Independent International Panel of Experts for Flood Studies of Inland Rail in Queensland

Draft Report on Review of Helidon to Calvert Section

May 12, 2021

Figure 15: 1% AEP Existing Scenario Culvert Instability

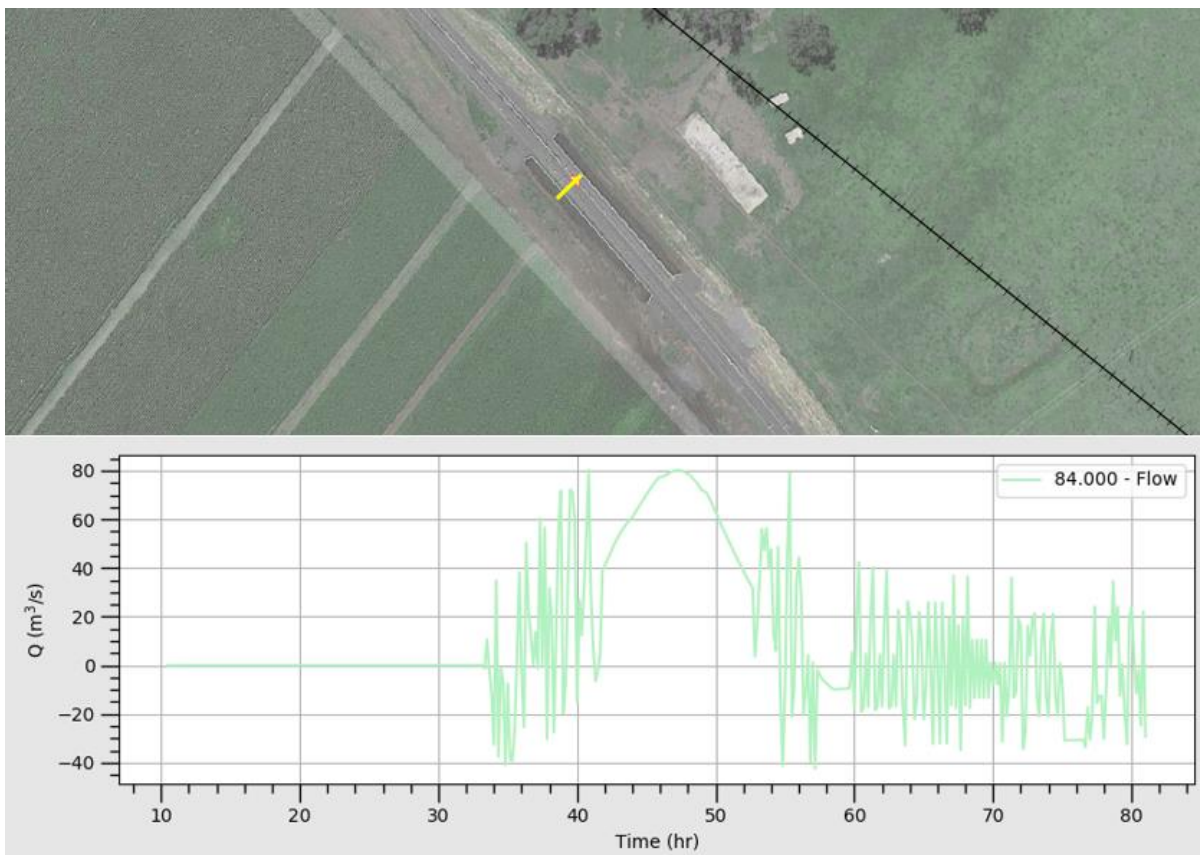
Review of the existing drainage structure modelling shows there are more than ten culverts that demonstrate flow instabilities. An example of this flow instability is shown at Culvert 84.000 located under the existing rail alignment downstream of Whitehouse Road as shown in Figure 15.

The Panel notes that this issue is impacting around 10% of included culverts, with many of these being located a significant distance away from the alignment. It is

Figure 21: Peak Flow Rate Comparison at Glenore Grove TUFLOW Model versus URBS and FFA from Technical Report

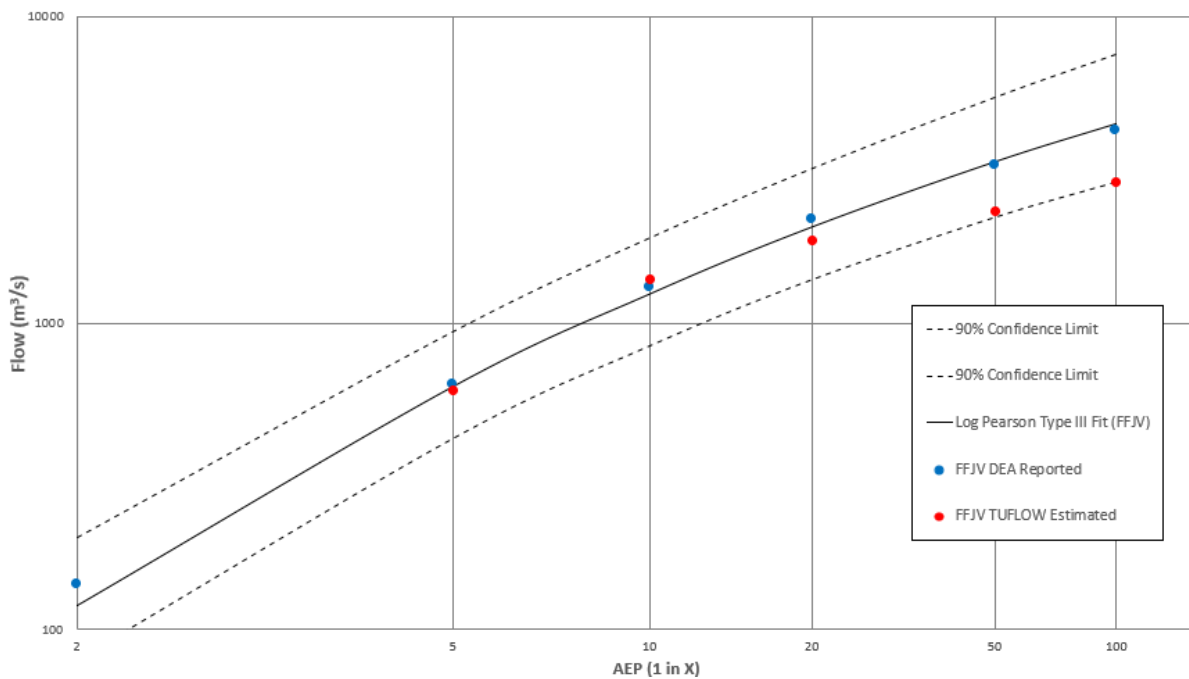
Furthermore, the Panel has undertaken an assessment of the TUFLOW design flow rates against the reported URBS and FFA estimated peak flow rates at Glenore Grove as presented in Figure 21. Even with the modification to the beta value, there are significant differences (underestimation) between the TUFLOW peak design flow estimates and the FFA for the 5%, 2% and 1% AEP events. The Panel notes that the

Figure 24: Change in Water Level for PMF Event at Sensitive Receptors (Figures A-10B-1 and A-10B-2 from the Technical Report)

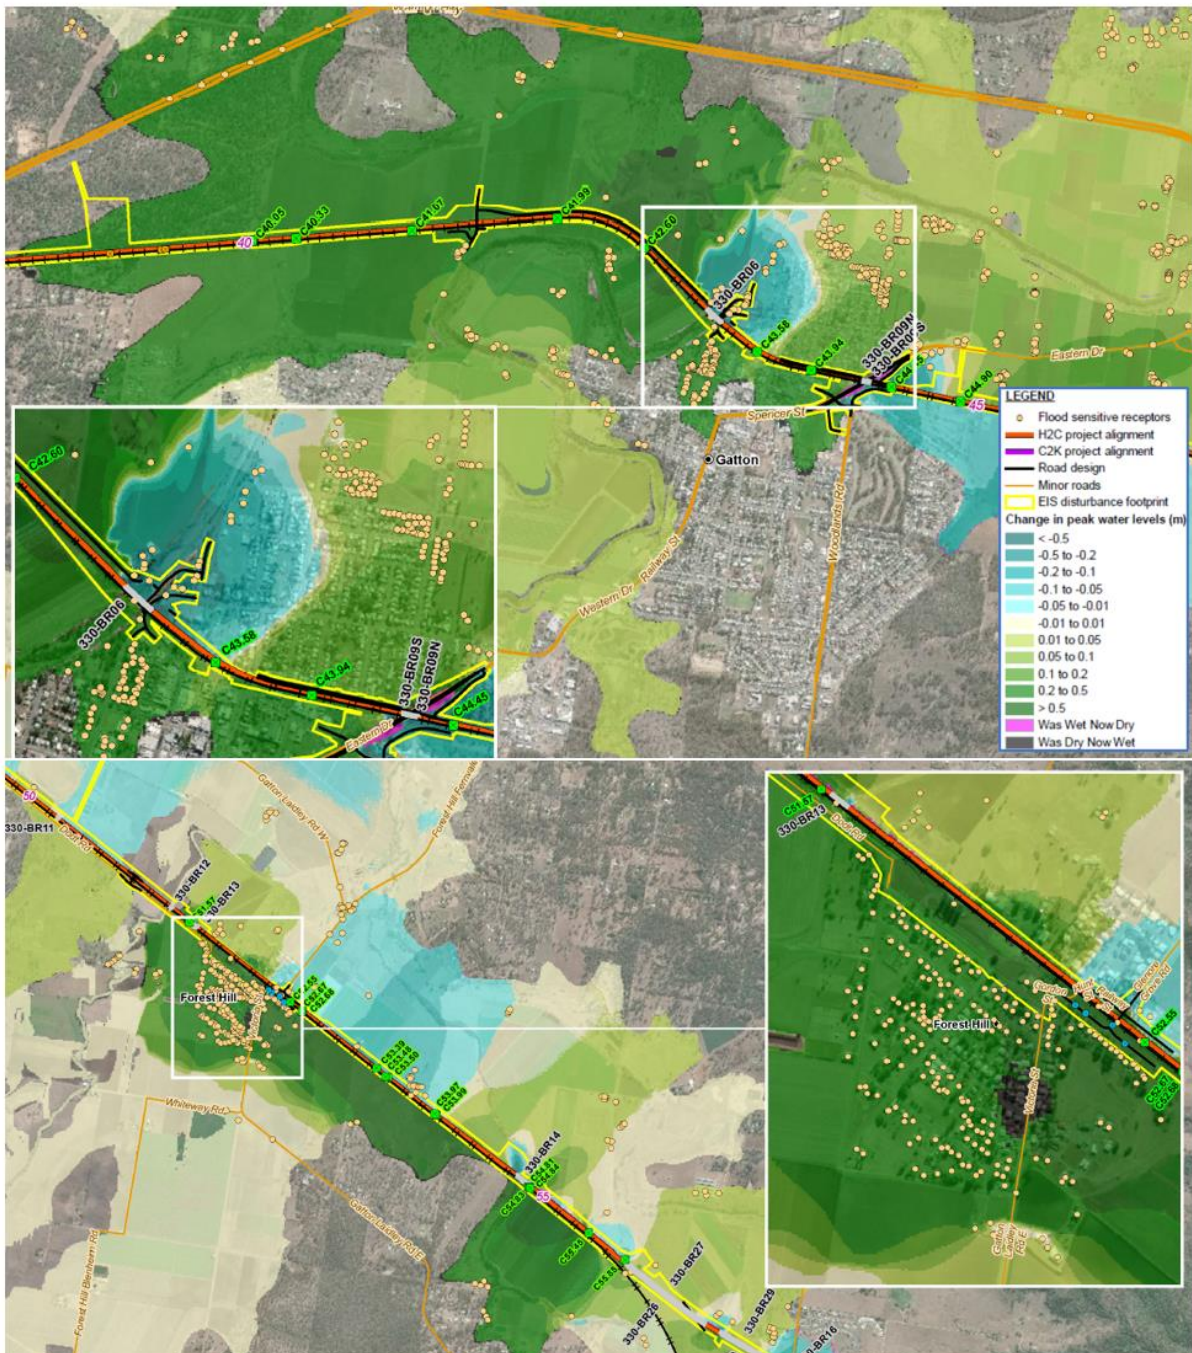
Further, while there is no strict criterion for the consideration of flood level impacts for extreme events, it is recommended that extreme events also be tabulated for the next phase of the assessment. For example, the impact maps for the PMF event, shown in Figure 10, demonstrate that impacts at some receptors could be in excess of 0.5m.

The Tables and figures do not list the relevant flood level (or at least ground level if no survey data is available) at each receptor. This makes the assessment of any increase in level difficult as the proximity of flood waters to the floor of a structure and the depth of water over the floor are key criteria for the consideration of impacts. It is recommended that flood/ground level information be surveyed and added to the tables as part of further design stages in order for change in flood level at each receptor to be assessed.

Figure 3: Bremer River Catchment in Western Creek Delineation

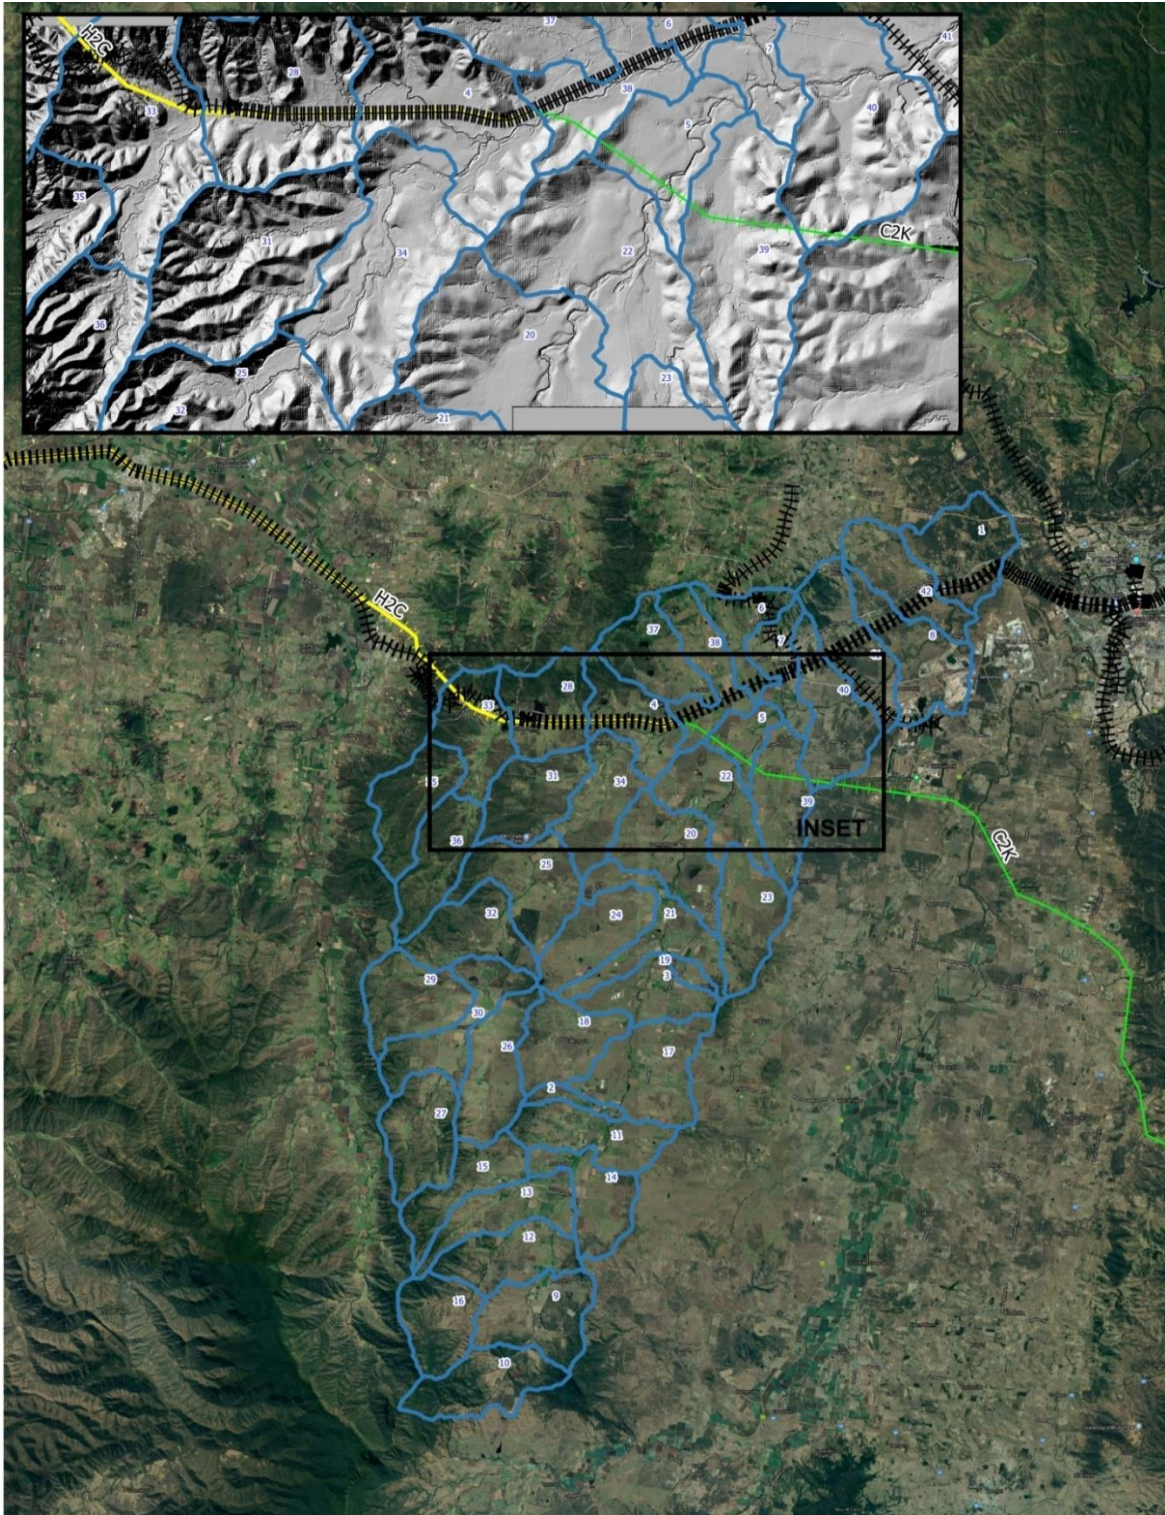
The sub-catchment delineation adopted for the Western Creek portion of the Bremer River catchment is the same as that used for the Brisbane River Catchment Flood Study as shown in Figure 3 which also includes location of the rail alignment. No refinement of the sub-catchment extents was undertaken considering the location of the rail alignment. The same sub-catchments were used for the consideration of existing and developed conditions.

For detailed design, it is considered necessary to divide these sub-catchments to reflect the areas either side of the alignment reflect conditions in the vicinity of the railway.

Figure 4: Upstream Model Boundary and Upstream Inflows

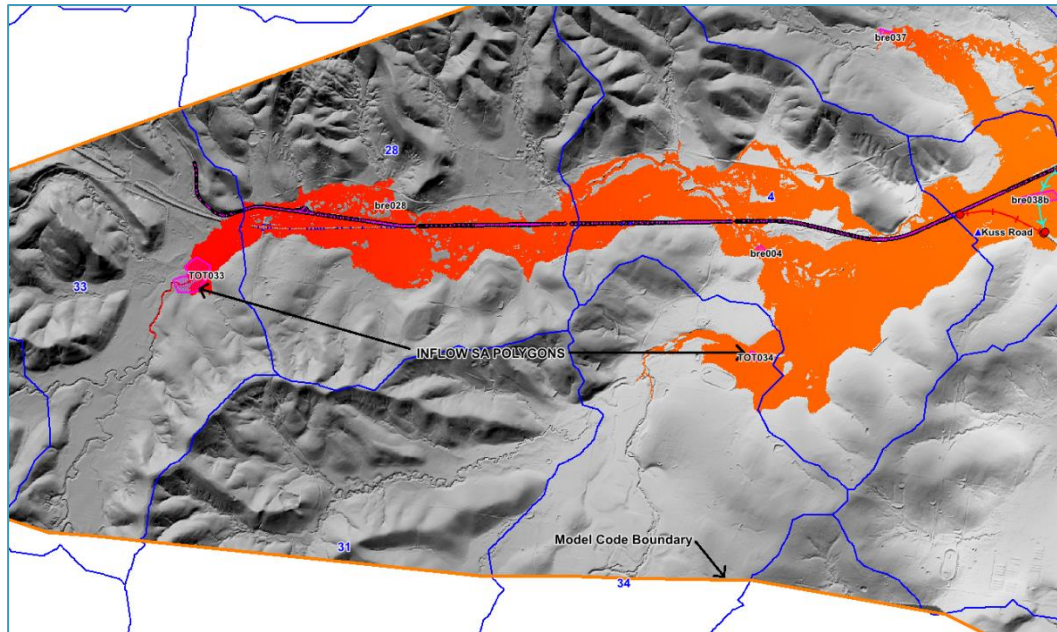
Figure 4 indicates the location of the boundary inflows TOT033 (representing the total flow including sub-catchment 33) and TOT034 (representing the total inflow including sub-catchment 34).

However, in the case of TOT034 the topography is relatively flat such that the lumped flows spread upstream.

In addition to the flood storage provided by these backwater areas, the inundation mapping produced by the model is suspect, as it reflects the lower flood level applicable at the point of inflow rather than the higher flood level likely to be applicable further upstream. In the case of the area upstream of the TOT034 inflow, Figure B-7F of the Technical Report indicates that five flood sensitive receptors are located in the affected area. The flood level at these receptors for a given event will be higher than that suggested by the Technical Report.

As noted in Section 2.3, the alignment crosses a number of sub-catchments. As shown in Figure 4, this results in the inconsistent application of inflows to the model.

Figure 6: Unstable Culvert Representation

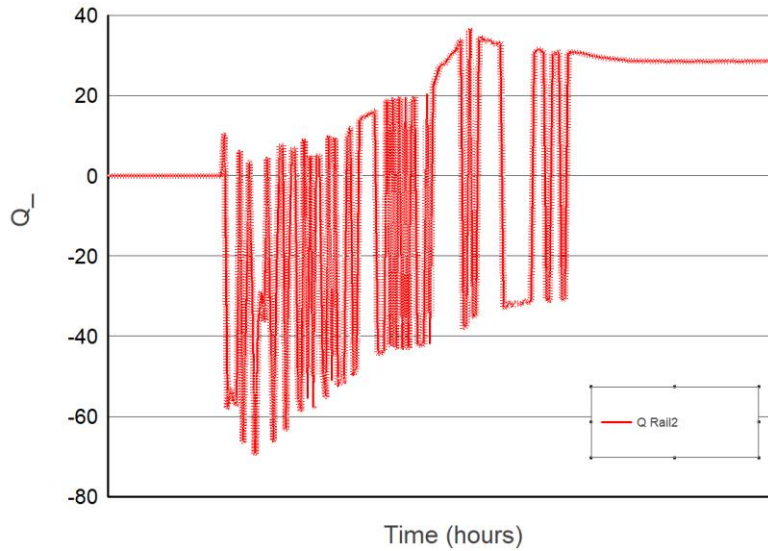
The model was found to be generally stable. Within the Western Creek catchment, a bank of existing culverts beneath the existing railway line (72 x 1.2 m x 0.9 m rectangular culverts, TUFLOW ID: Rail2 as shown in Figure 5) has connection issues resulting in unstable flow through the culverts (refer Figure 6). These culverts, in addition to further checks on all other 1D structures as required, needs to be rectified as part of further design to ensure they do not artificially impact on the rail design.

Figure 7: 2011 Calibration for Western Creek (Figure B2-D of Technical Report)

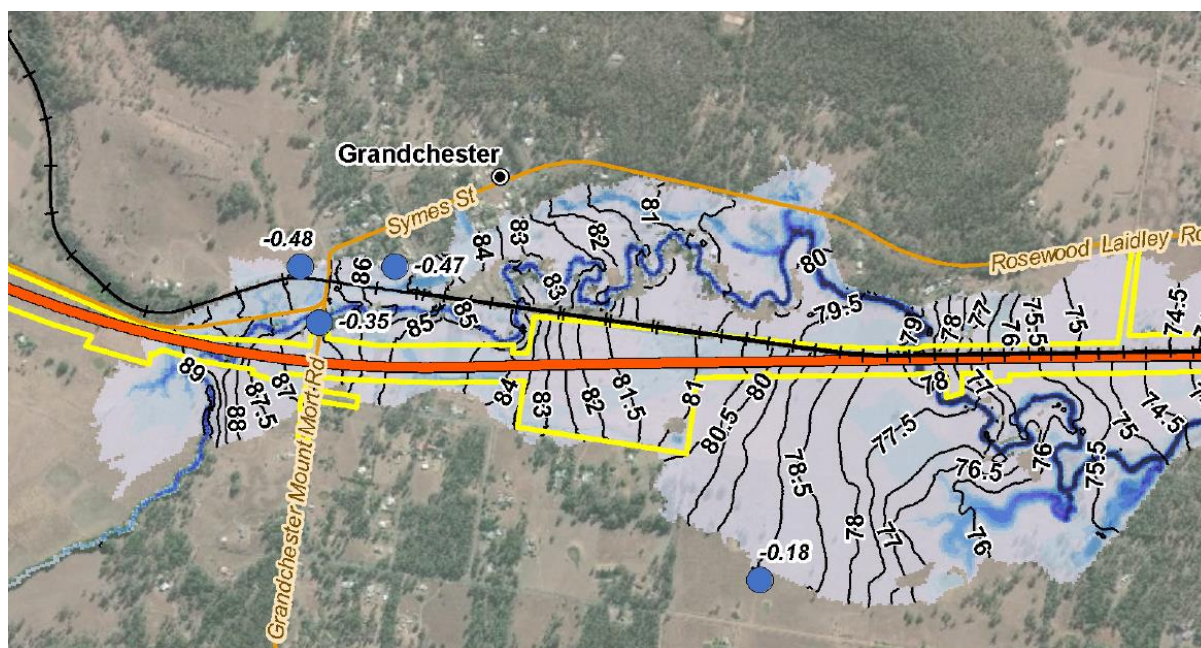
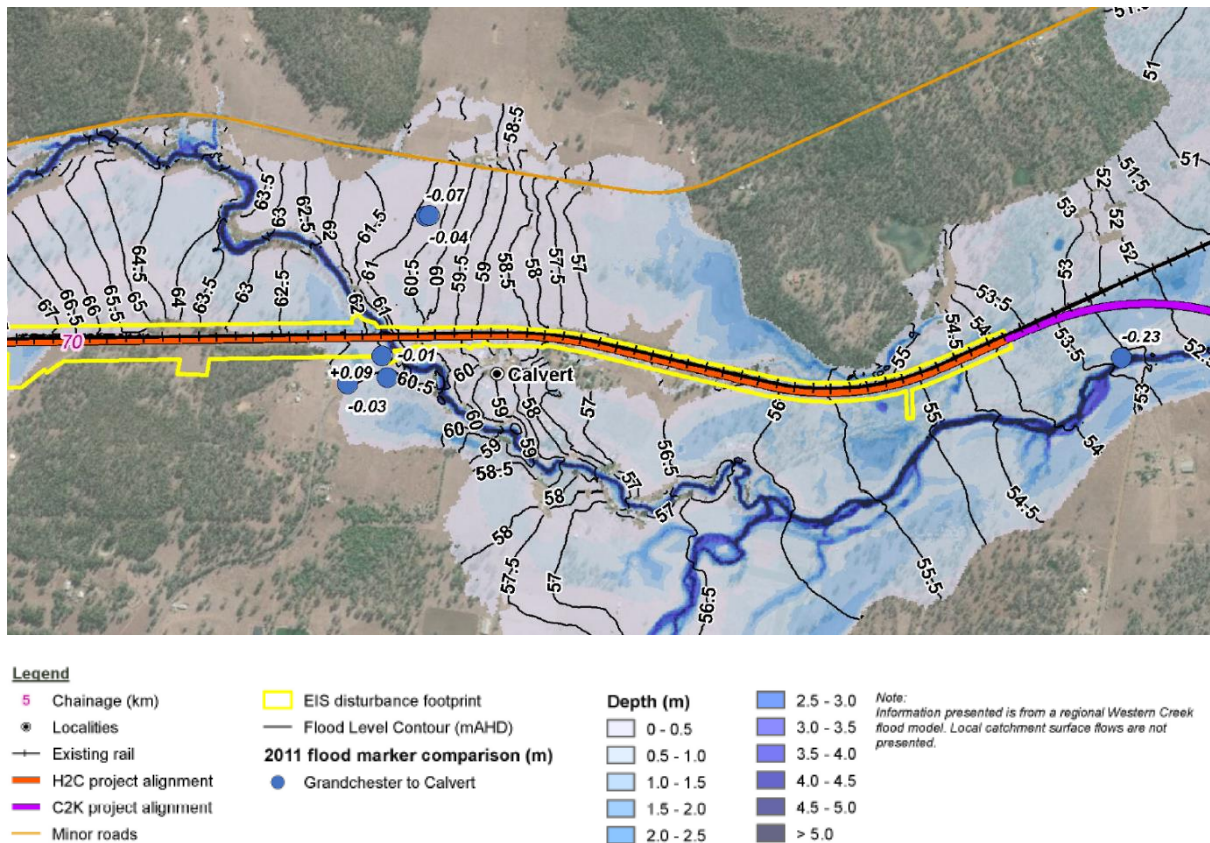
It can be highlighted that while the calibration of the 2011 event within Western Creek appears to be relatively good at Calvert, $\pm 100\text{mm}$, at Grandchester the levels are significantly and consistency lower by up to approximately 500mm as shown in Figure 7 and Figure 8.

Figure 10: Change in Water Level for PMF Event at Sensitive Receptors (Figures 13.26a and 13.26b of draft EIS)

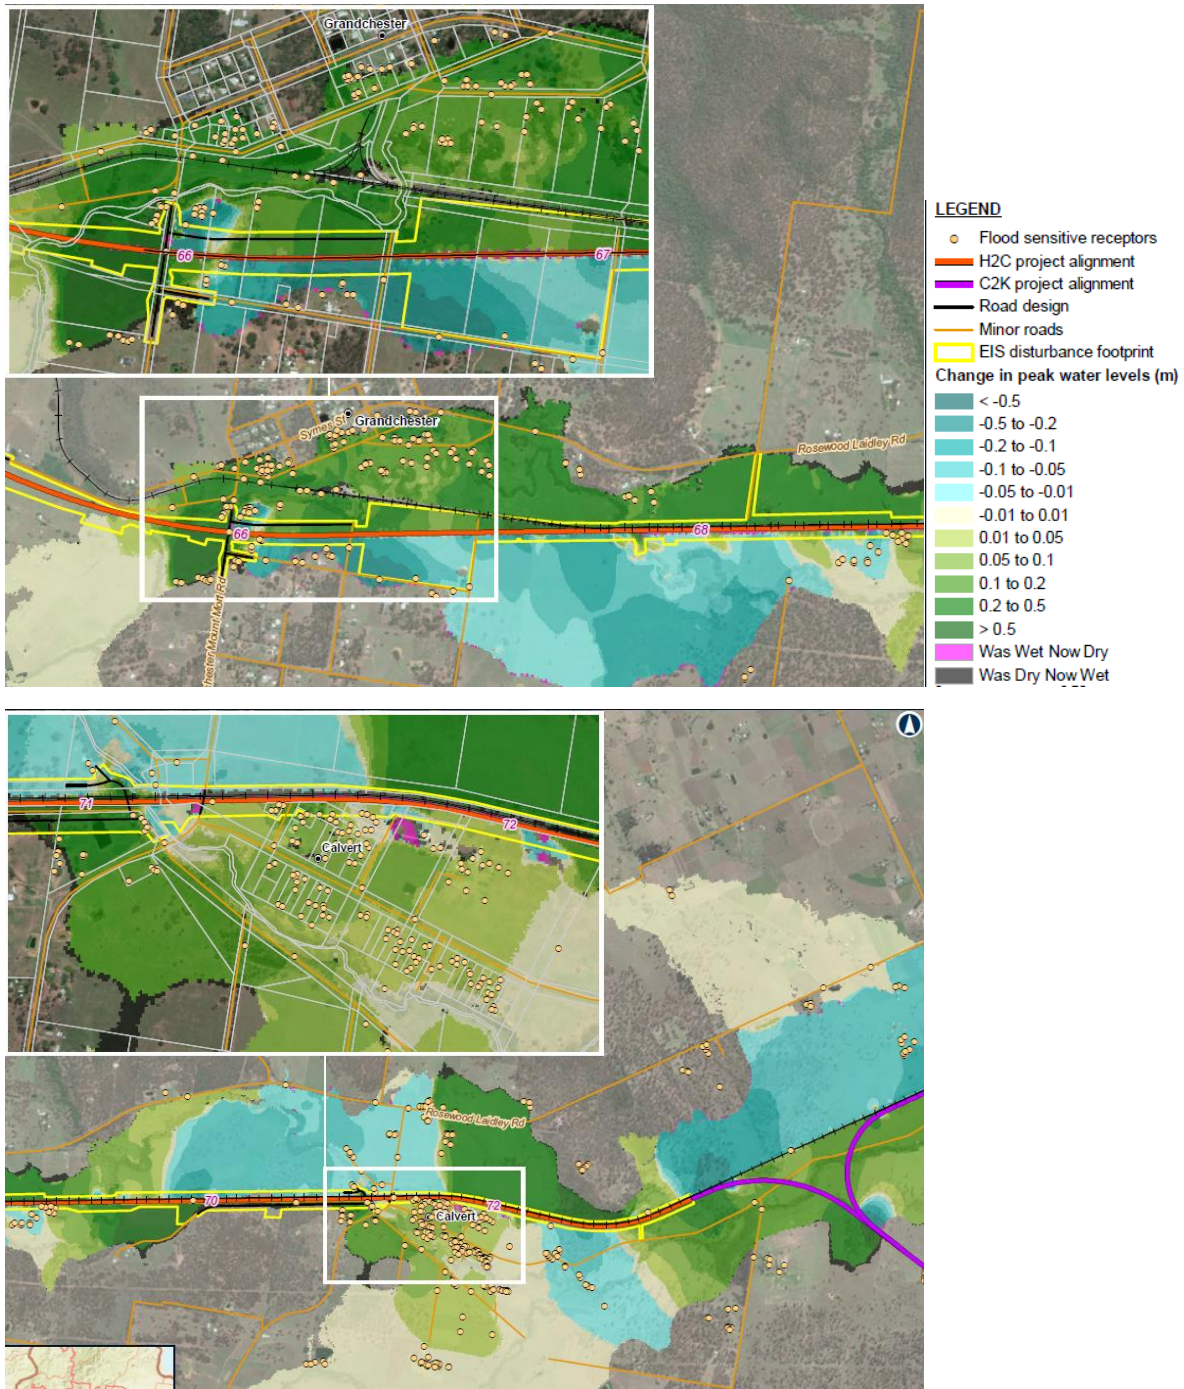
For example, the impact maps between Grandchester and Calvert for the PMF event are shown below in Figure 10. Impacts at some sensitive receptors could be in excess of 0.5 m.

The tables/maps do not list the relevant floor level (or at least ground level if no survey data is available) at each receptor. This makes the assessment of any increase in level difficult as the proximity of flood waters to the floor of a structure and the depth of water over the floor are key criteria for the consideration of impacts. It is recommended that floor/ground level information be surveyed and added to the tables as part of further design in order for the change in flood level at each receptor to be assessed. It is noted that the Engeny report contains some surveyed floor level information.

In this case, the increase in flood level in the vicinity of Grandchester is of significance as the embankment directs more flow to the north of the railway (refer Figure 10). The Panel recommends that in areas where the alignment is close to population centres, such as towns, the impact in extreme events (for example the 1 in 2,000 AEP) should not significantly increase for both flood levels and the number of affected properties. A target objective of less than 200 mm increase in flood levels would achieve this objective. Furthermore, the design should ensure that there is no significant increase in flood hazard to the community.
